**PLEASANT PRAIRIE PLAN COMMISSION MEETING
VILLAGE HALL AUDITORIUM
9915 39th AVENUE
PLEASANT PRAIRIE, WISCONSIN
6:00 P.M.
MARCH 9, 2015**

- A. Consider the request of Peter Kucha, of Eppstein Uhen Architects, Inc., agent for Uline for approval of **Preliminary Site and Operational Plans** for mass grading and preliminary approval of an office building and site improvements for a Uline Headquarters Office building (H2) generally located at the 11200 block of 120th Avenue (West Frontage Road).

Consider the request of Peter Kucha, of Eppstein Uhen Architects, Inc., agent for Uline for approval of **Preliminary Site and Operational Plans** for mass grading and preliminary approval of an office building and site improvements for a Uline Headquarters Office building (H2) generally located at the 11200 block of 120th Avenue (West Frontage Road).

ONSITE CIVIL ENGINEERING INFRASTRUCTURE PLANS

www.pinnacle-engr.com
FOR REVIEW
EXISTING CONDITIONS

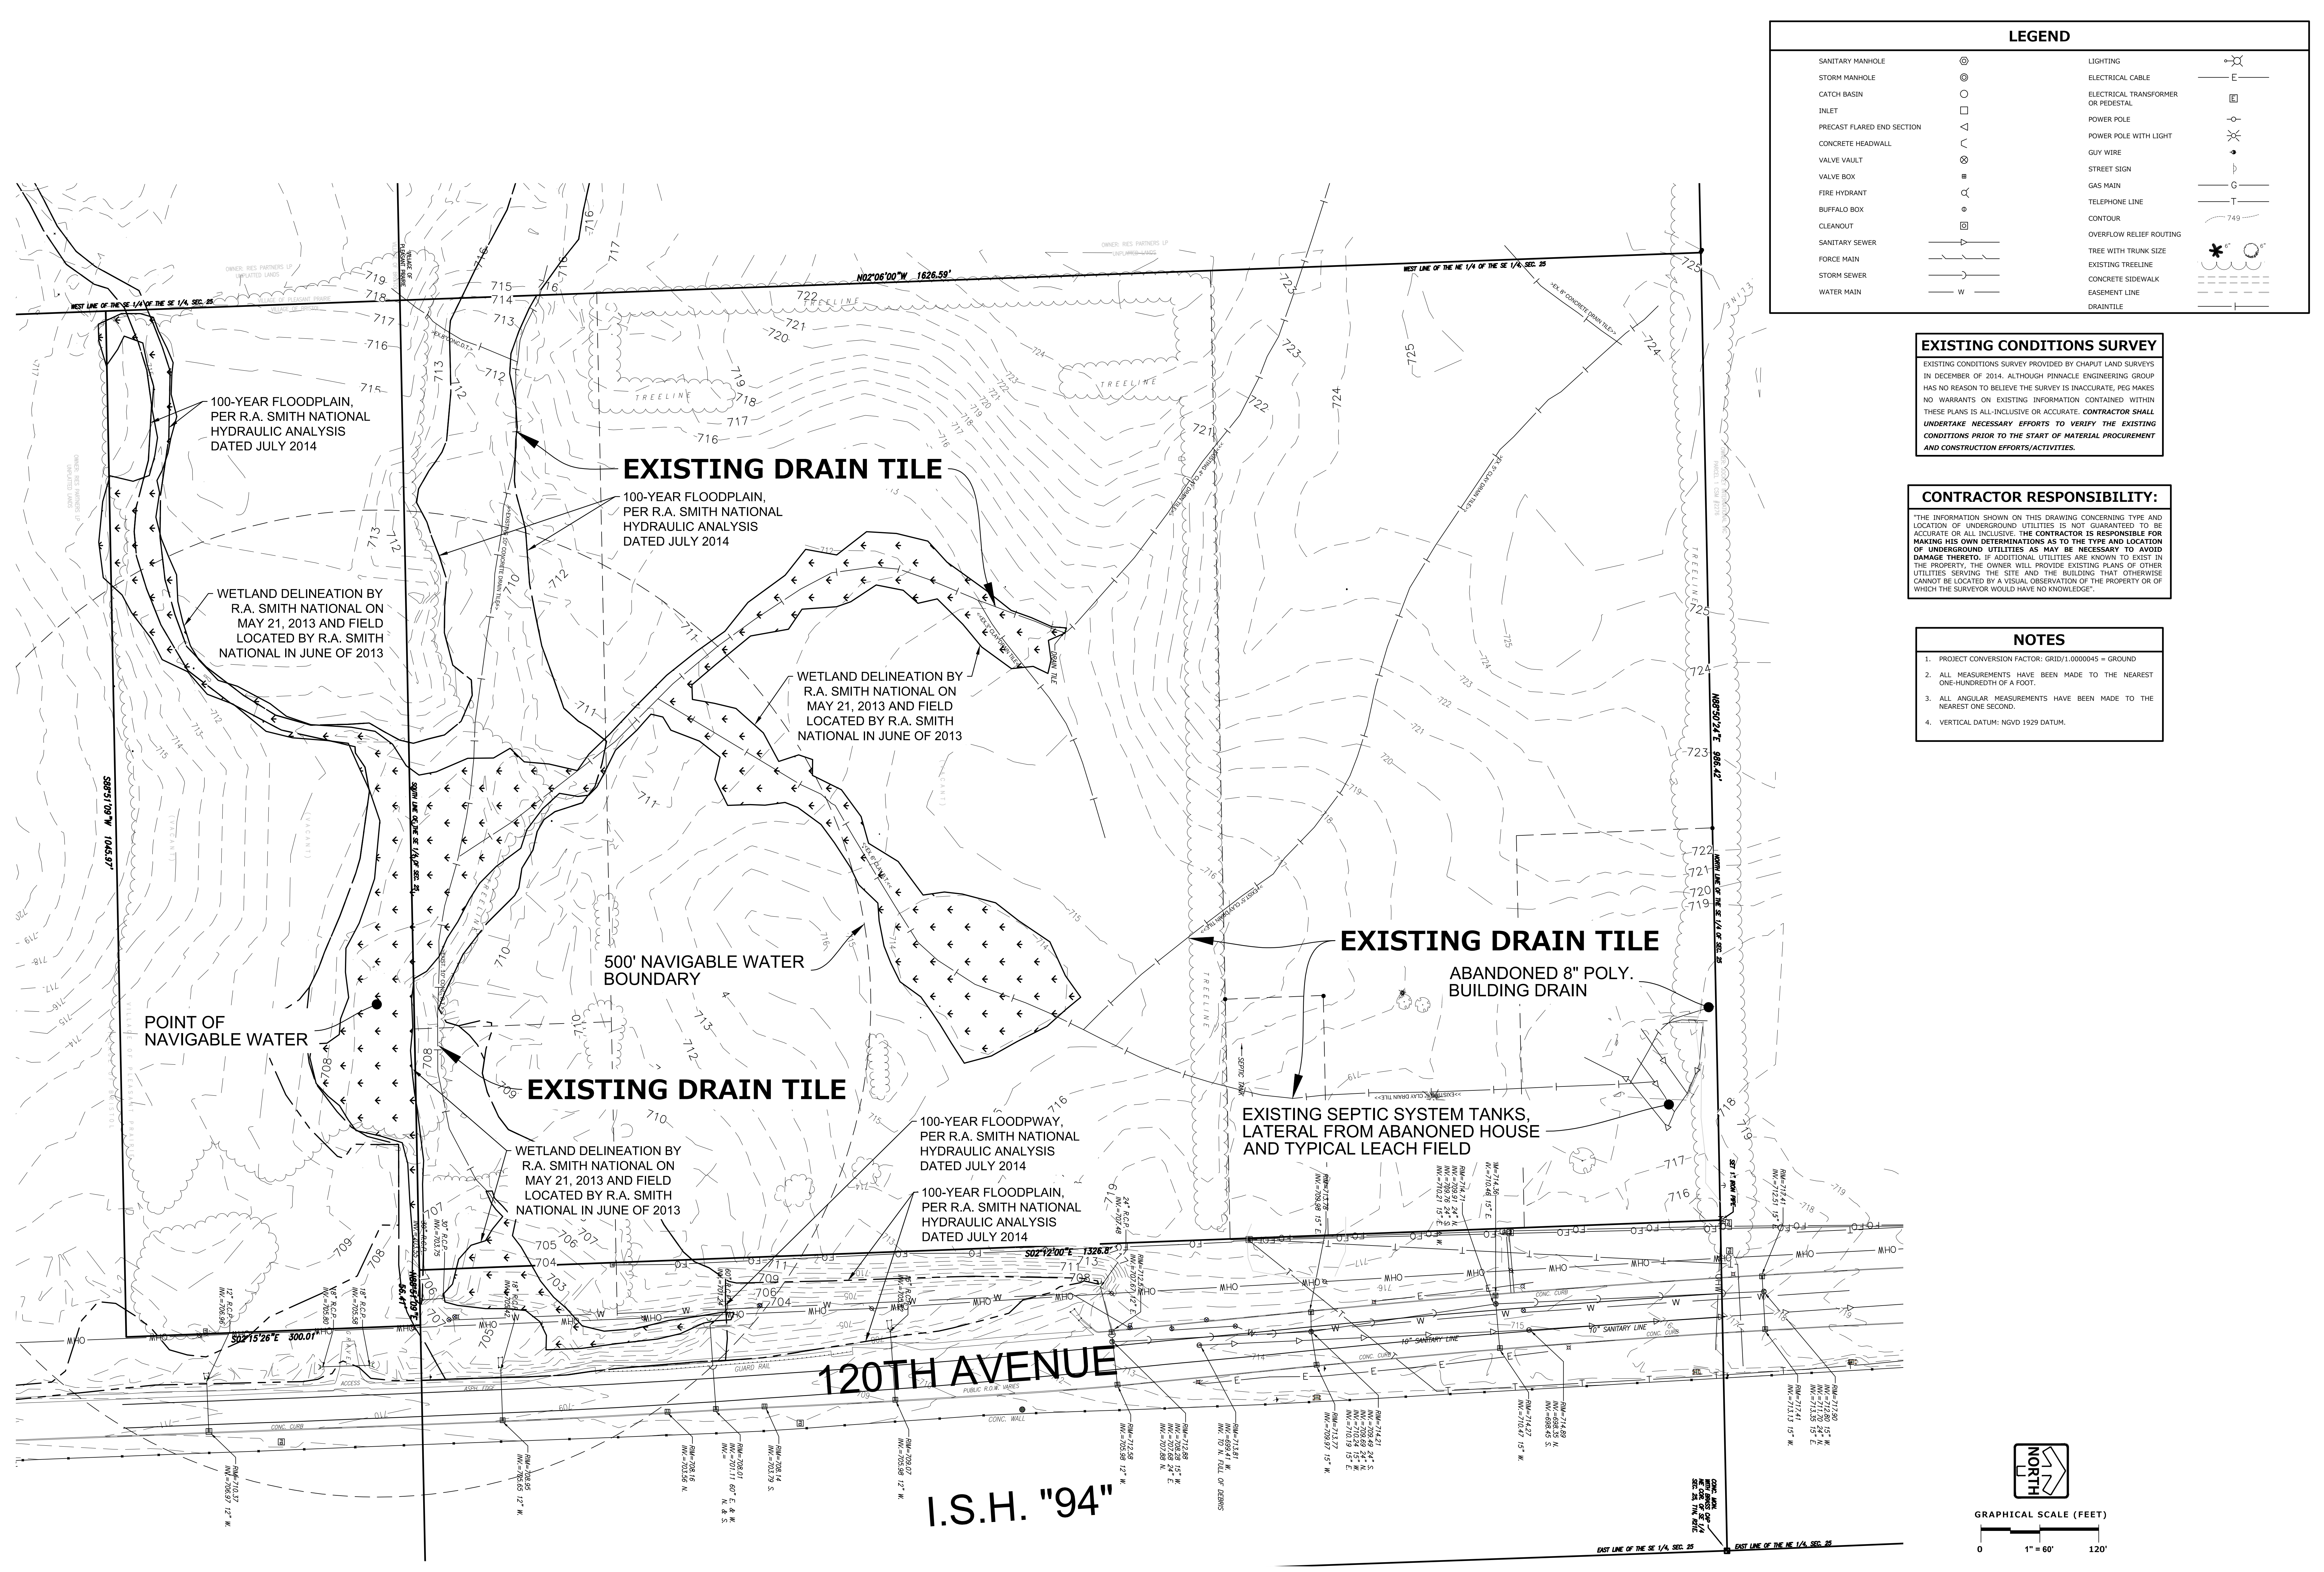
- a. Interstate Highway 94 should be labeled as IH-94 or I-94 not I.H.S. 94.
 - b. What is the Point of Navigable Water way on Sheet C-2? Is it measuring a setback to an adjacent structure? What is the elevation?

SHEET
C-3
C-14

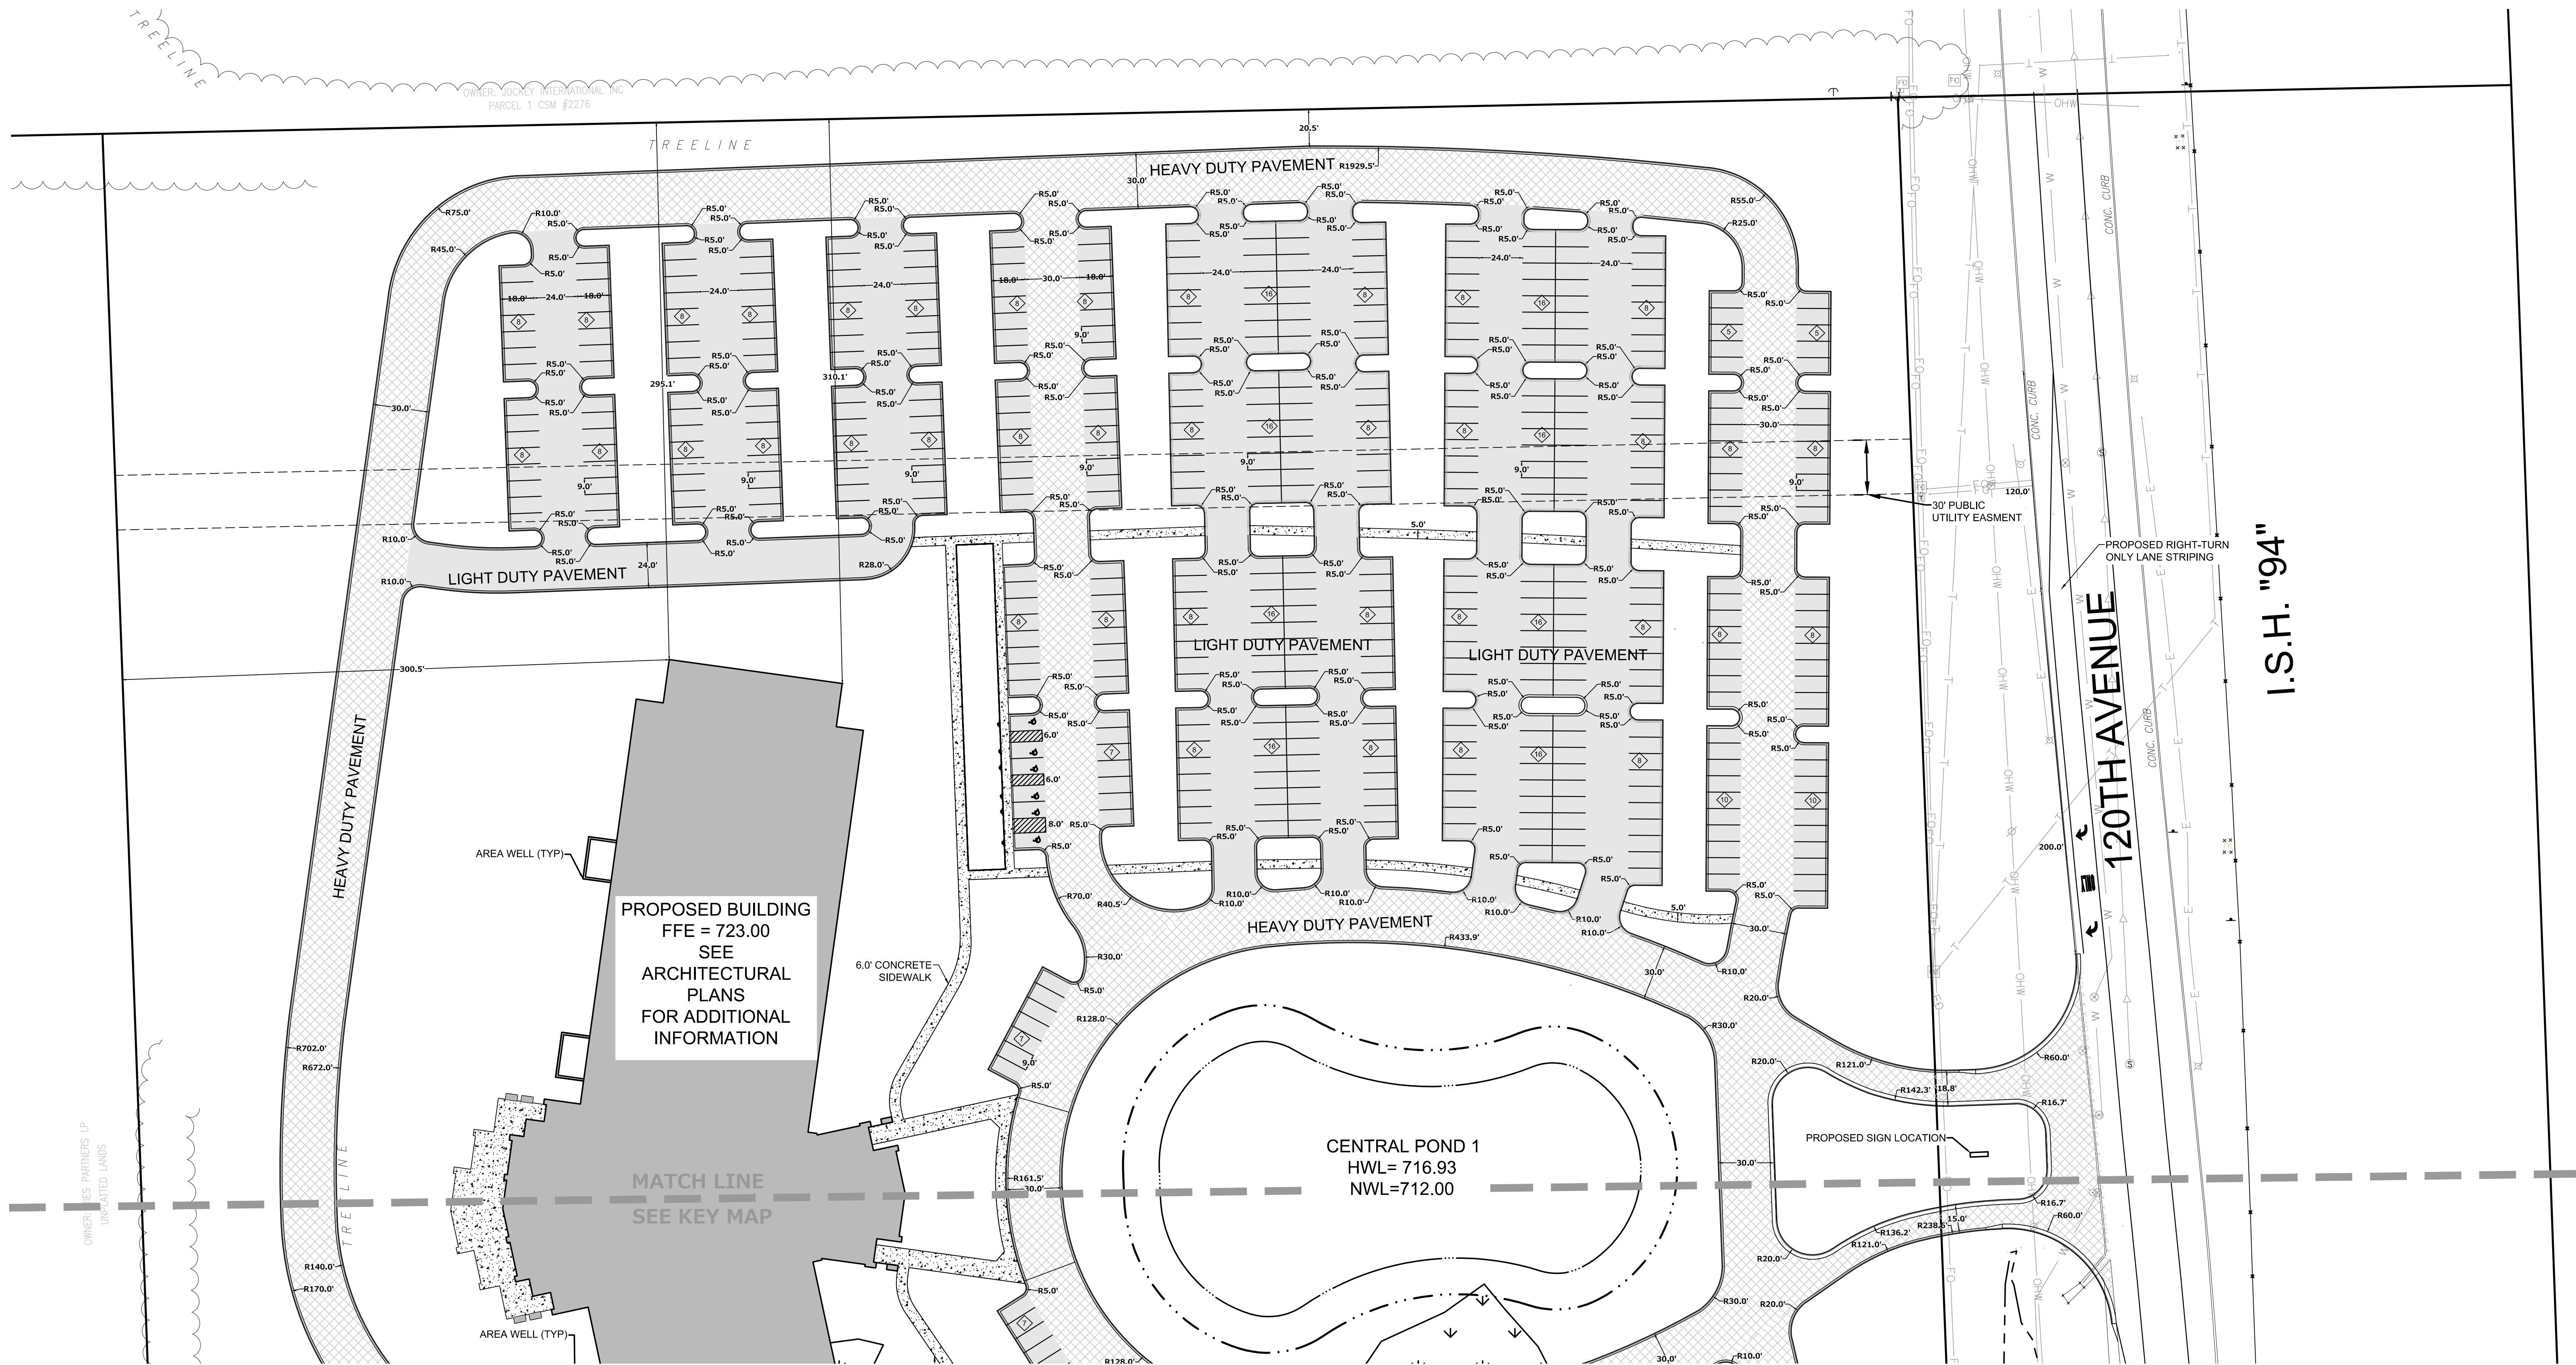
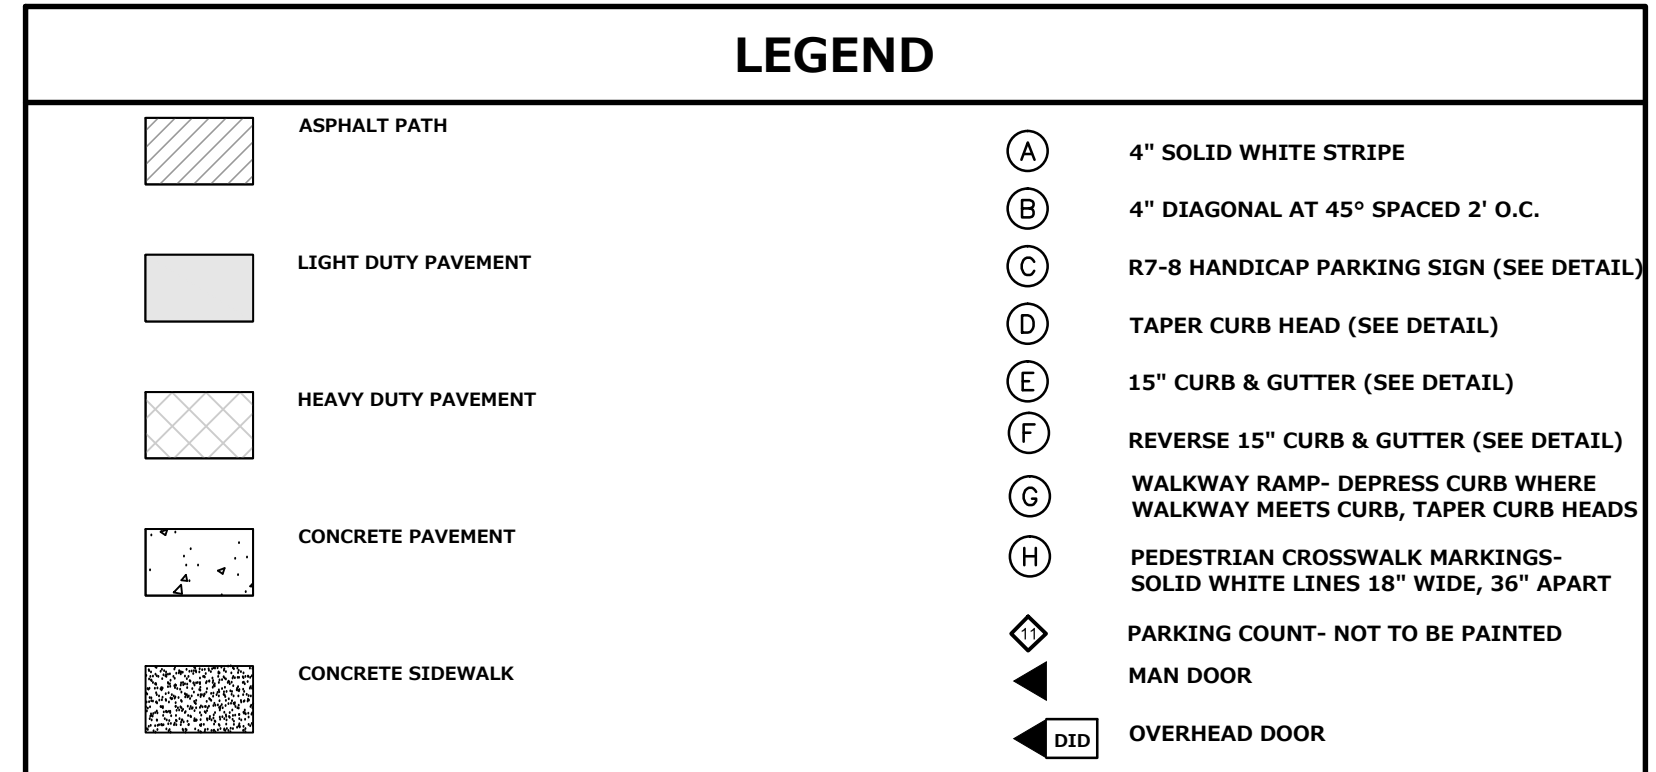
- (1) Revise note 16 (Asphaltic Concrete Paving Specifications) to utilize the current edition of the State Highway Specifications.
 - (2) Show travel directions of any one way traffic locations on the site plans.

- c. All Easements shown on the CSM shall be shown on the Engineering Plans, Site Plans and Landscaped Plans.
- d. Plan Sheet C-3: The number of parking spaces indicated in the "Parking Counts" table do not match the number of parking spaces provided [Section (j)] of the written Operation Plan. These numbers shall be re-checked and corrected so that the parking count numbers are consistent throughout the plan submittal.
